**ORDINANCE NO. \_\_\_\_\_**

An ordinance amending Title 30 – Residential Code of the Los Angeles County Code, by adopting the 2013 California Residential Code by reference, with certain changes and modifications.

**FIGURE R403.1.5  
 STEPPED FOOTING**

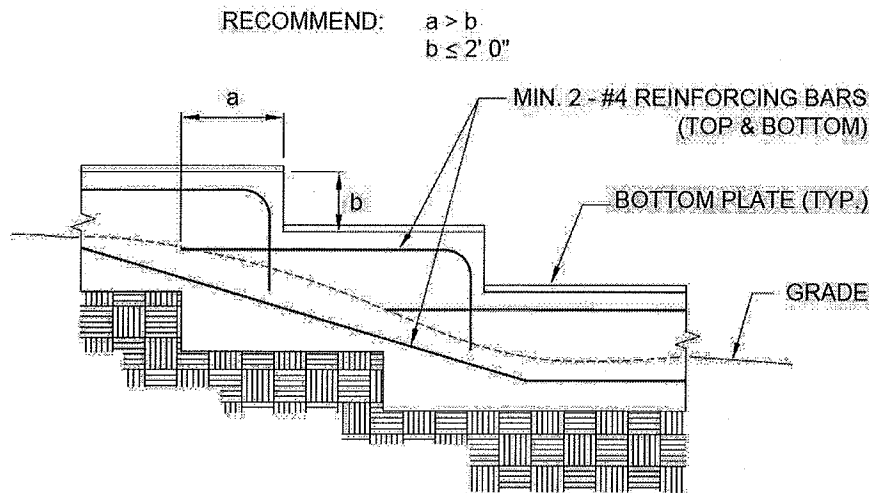
For structures located in Seismic Design Categories D<sub>0</sub>, D<sub>1</sub>, or D<sub>2</sub>, stepped footings shall be reinforced with two No. 4 reinforcing bars located at the top and bottom of the footings as shown in Figure R403.1.5.

**SECTION 31.** Figure R403.1.5 is hereby added to read as follows:

**FIGURE R503.2.4**

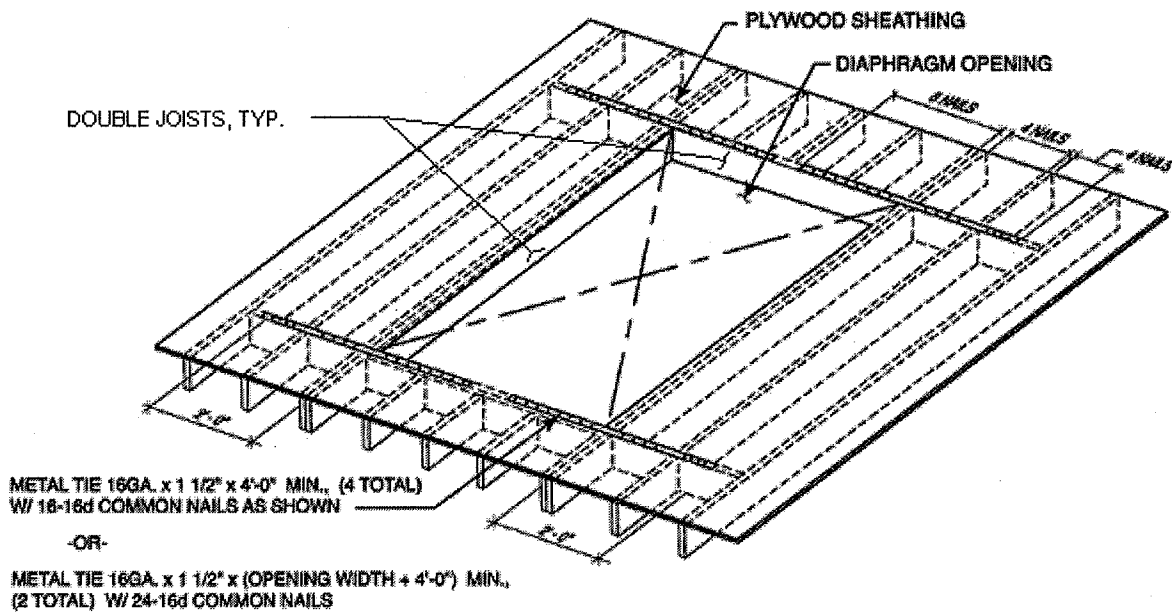
Openings in horizontal diaphragms with a dimension perpendicular to the joist that is greater than 4 feet (1.2 m) shall be constructed in accordance with Figure R503.2.4.

- a. Blockings shall be provided beyond headers.
- b. Metal ties not less than 0.058 inch [1.47 mm (16 galvanized gage)] by 1.5 inches (38 mm) wide with eight 16d common nails on each side of the header-joist intersection. The metal ties shall have a minimum yield of 33,000 psi (227 MPa).

c. Openings in diaphragms shall be further limited in accordance with Section R301.2.2.2.5.

R503.2.4	Geological	Section R502.10 of the Code does not provide any prescriptive criteria to limit the maximum floor opening size nor does Section R503 provide any details to address the issue of shear transfer near larger floor openings. With the higher seismic demand placed on buildings and structures in this region, it is important to ensure that a complete load path is provided to reduce or eliminate potential damages caused by seismic forces. Requiring blocking with metal ties around larger floor openings and limiting opening size is consistent with the requirements of Section R301.2.2.2.5.
R602.3.2	Geological	Los Angeles County is prone to seismic activity due to the existence of active faults in the Southern California area. The cities and County of the Los Angeles region have taken extra measures to maintain the structural integrity of the framing of the shear walls when designed for high levels of seismic loads by eliminating single top plate construction. The performance of modern day braced wall panel construction is directly related to an adequate load path extending from the roof diaphragm to the foundation system. This proposed amendment is a continuation of an amendment adopted during the previous code adoption cycle.

**FIGURE R602.10.6.1  
METHOD ABW—ALTERNATE BRACED WALL PANEL**

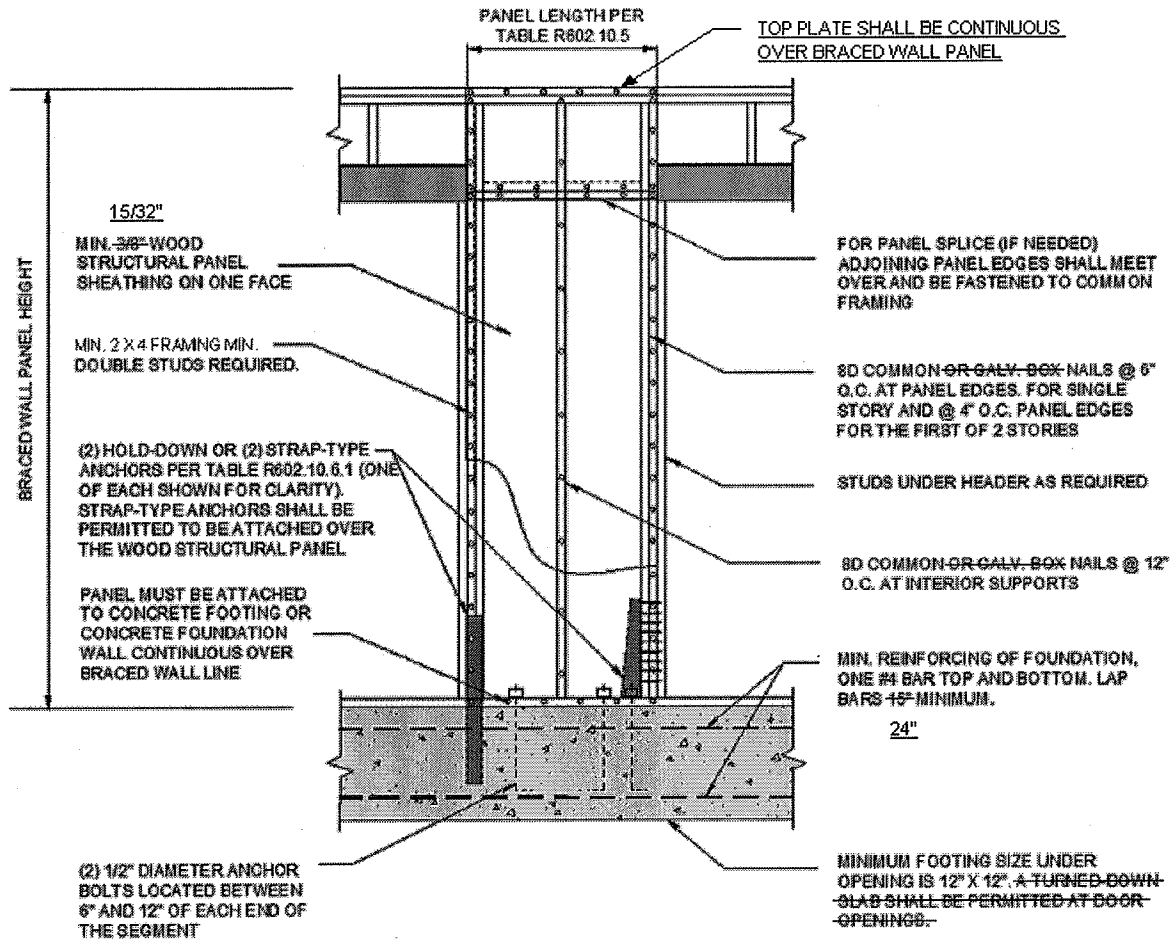
Figure R602.10.6.1 is amended to read as follows:

FIGURE R602.10.6.4  
METHOD CS-PF-CONTINUOUSLY SHEATHED PORTAL FRAME PANEL CONSTRUCTION

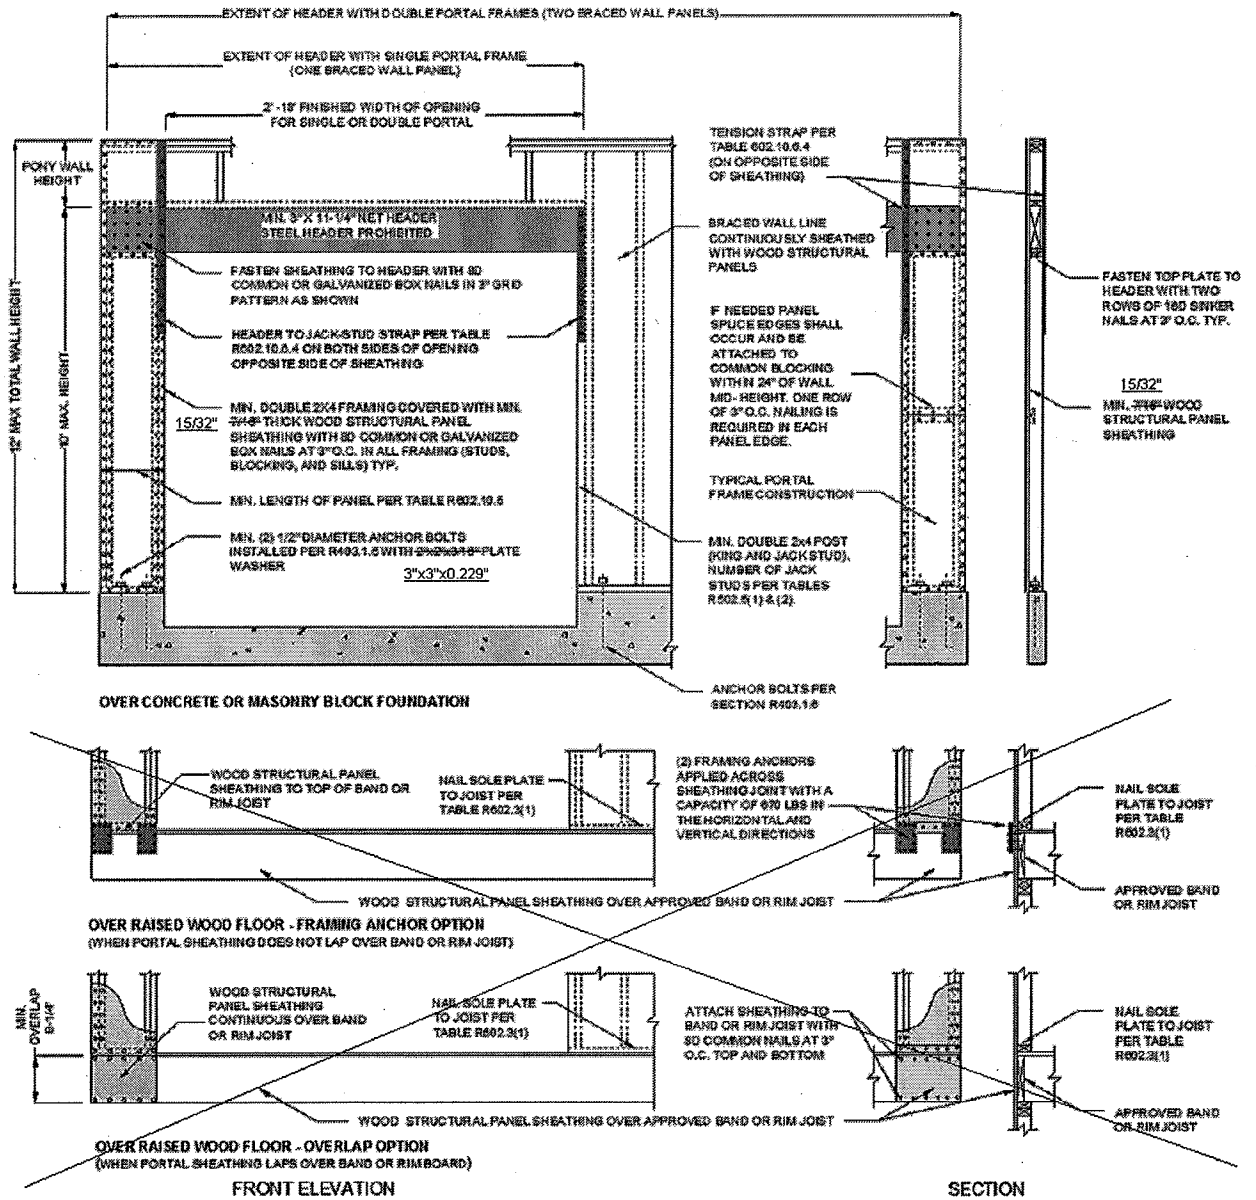
e. Maximum opening height for CS-PF is 10 feet in accordance with Figure R602.10.6.4, but wall height may be increased to 12 feet with pony wall.

**SECTION 43.** Figure R602.10.6.4 is hereby amended to read as follows:

Figure R602.10.6.4	Geological	3/8" thick 3 ply-plywood shear walls experienced many failures during the Northridge Earthquake. The poor performance of such shear walls sheathed in the 1994 Northridge Earthquake was investigated by SEAOSC and the Los Angeles City Joint Task Force. The cities and County of the Los Angeles region have taken extra measures to maintain the structural integrity of the framing of the shear walls when designed for high levels of seismic loads. The proposal in which "washers shall be a minimum of 0.229 inch by 3 inches by 3 inches in size" is consistent with Section R602.11.1 of the California Residential Code and Section 2308.12.8 of the California Building Code. This proposed amendment is a continuation of an amendment adopted during the previous code adoption cycle.
R602.10.9.1	Geological	Los Angeles County is prone to seismic activity due to the existence of active faults in the Southern California area. The performance of modern day braced wall panel
